### INTERMOUNTAIN POWER SERVICE CORPORATION

SUBJECT: Response to Condition of Unit 2 Burners

**Intermountain Power Service Corp.  
ABT Siemens Warranty Claim**

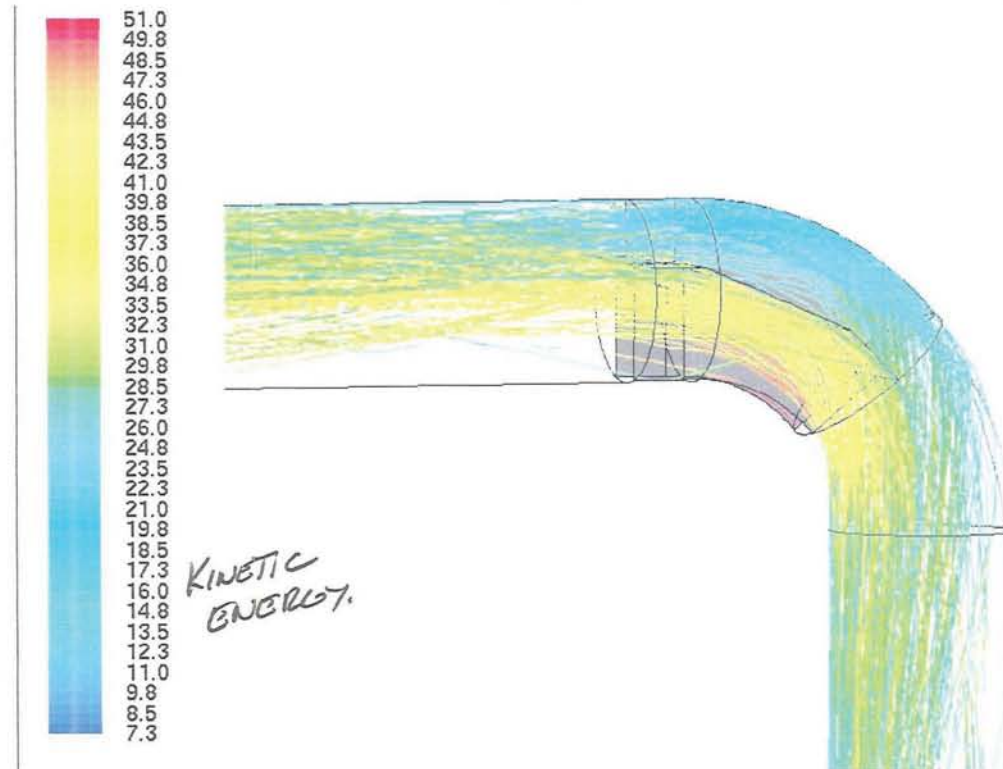
There is material loss at the burner nozzle tip, "X" vane at the coal pipe elbow and the burner barrel are a result of coal and air flows being higher than design plus stratification of the coal particles in the coal pipe entering the 90° elbow.

The burner barrel is experiencing permanent deformation due to higher than expected temperatures at the interface between the nozzle and barrel. The burner barrel will use a SS spool piece to extend back into the burner barrel.

Establish the correct primary airflow for normal operation – The plant has not been operating per the B&W mill performance curve supplied in the contract. The mill curve supplied in the contract did not reflect the revision by B&W in 1992. Also, the plant has been operating at higher seal air flows

Definition of requirements for cooling air when the burner is out of service – the Operations and Maintenance manual will have to be revised to address out of service operation

## Erosion and Mill Air Flow

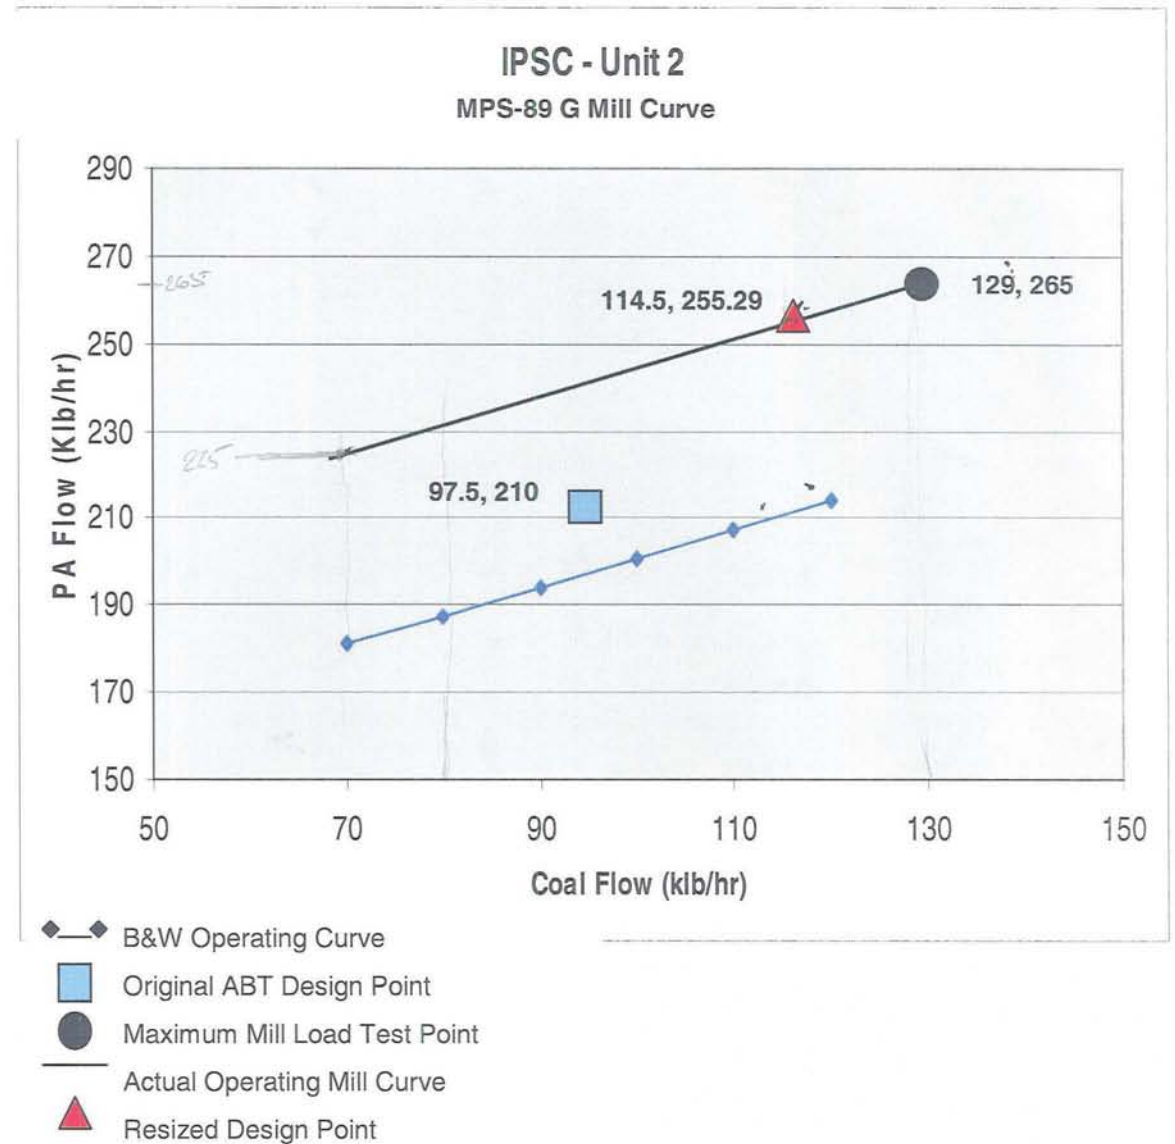
Erosion is originating at the transition slope from the round barrel to the 6 lobe exit. This is consistent with the results of the CFD model. The metallurgical analysis performed by Tordonato Energy Consultants identified erosion as a the contributor cause of the nozzle cracking. The high temperatures at the weld between the nozzle and burner barrel increased the stress which also contributed to the cracking. There was no evidence of corrosion.

The revised fuel injector design will increase the cross sectional area of the nozzle to reduce velocities, lengthen and flatten the slope of the transition ramp and replace the round elbow with a "Flat back" design to allow dispersion of the coal particles across the flow area of the nozzle.

## Thermal Stress

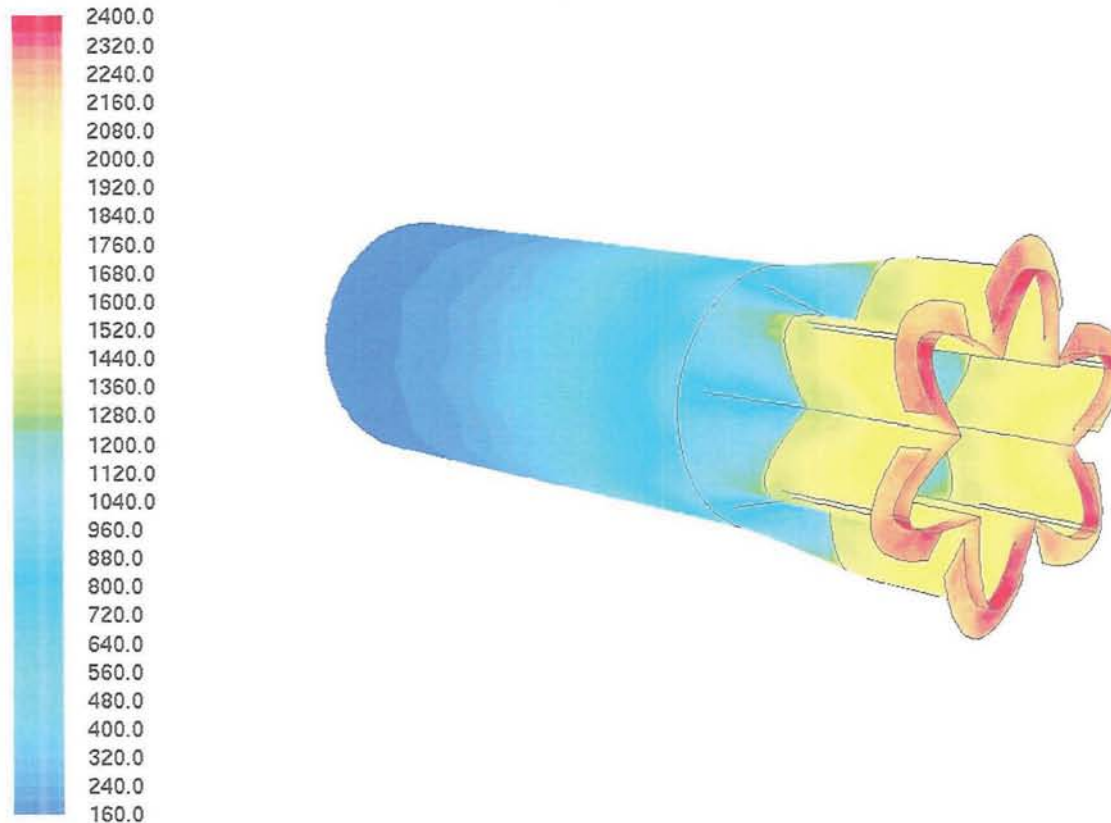
The furnace radiation model shows that the heat conducted back to the burner barrel to be higher than expected. The revised fuel injector will use a spool piece of 253MA stainless steel to make the transition from the nozzle to the barrel. The revised fuel injector shall use refractory tile to shield the burner barrel from radiation from the furnace and to minimize erosion. This thermal model does not model the cooling of the secondary air on the tip.

### Thermal Stress

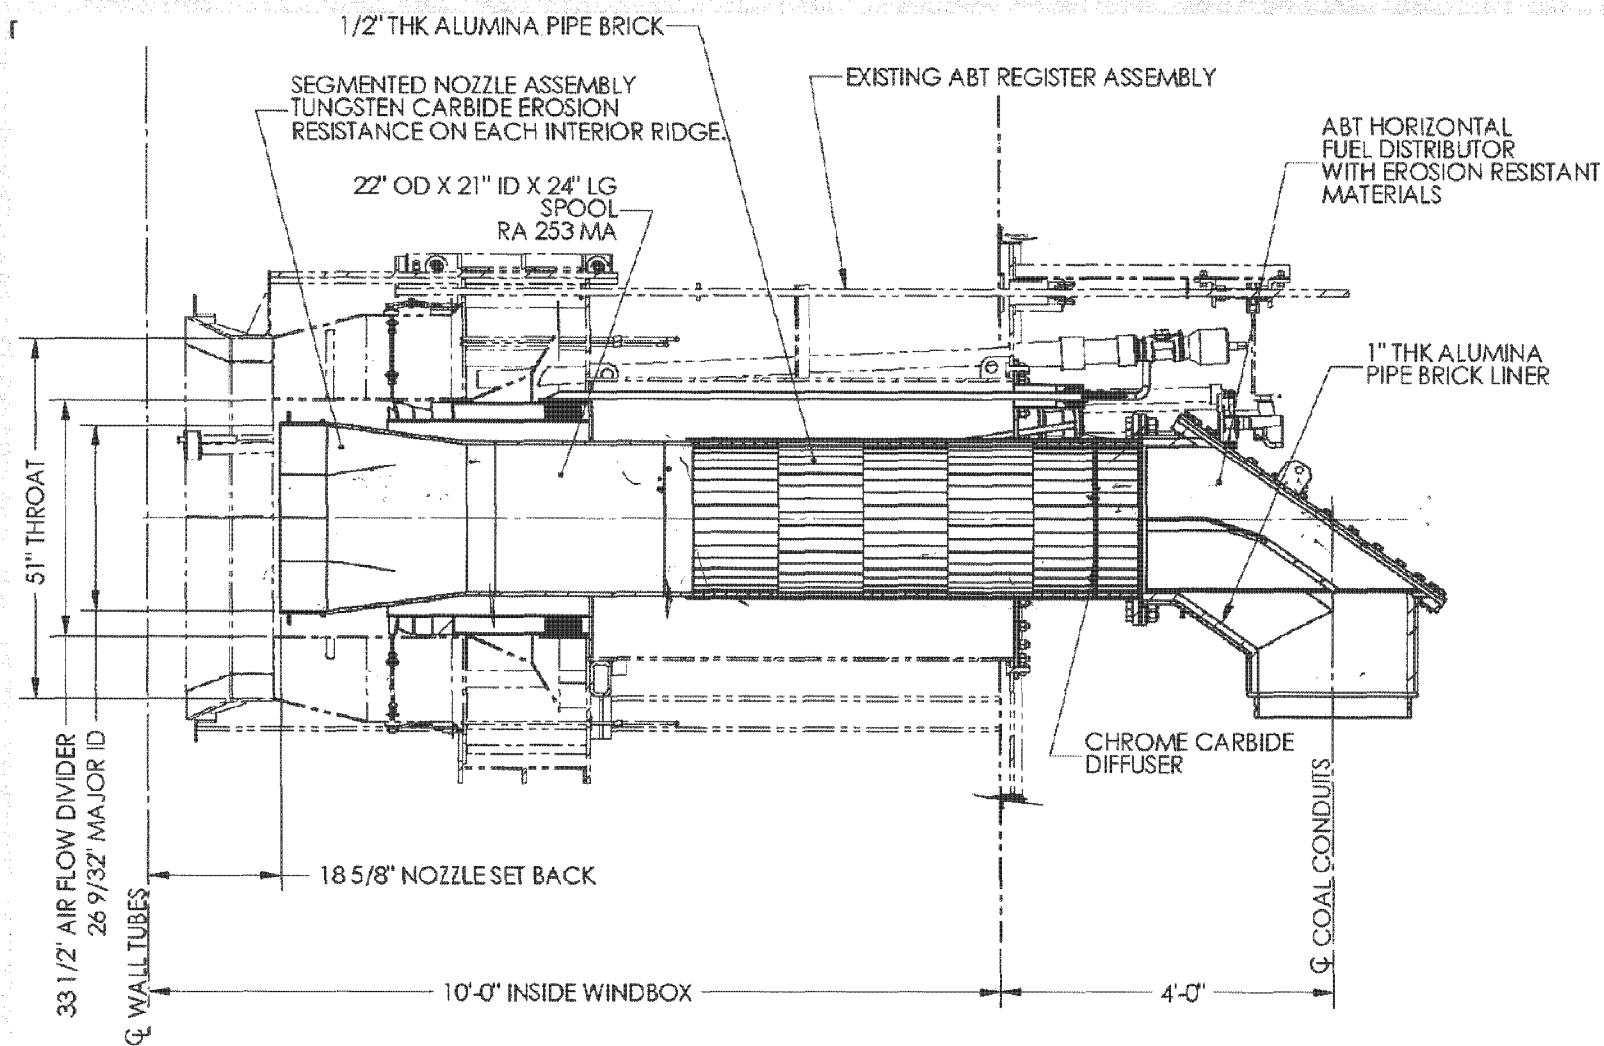
The off line burners are plugging with slag indicating that furnace gases are back flowing into the nozzle area. This creates very high temperatures that the nozzles were not designed for. A minimum air flow required to prevent this must maintained.
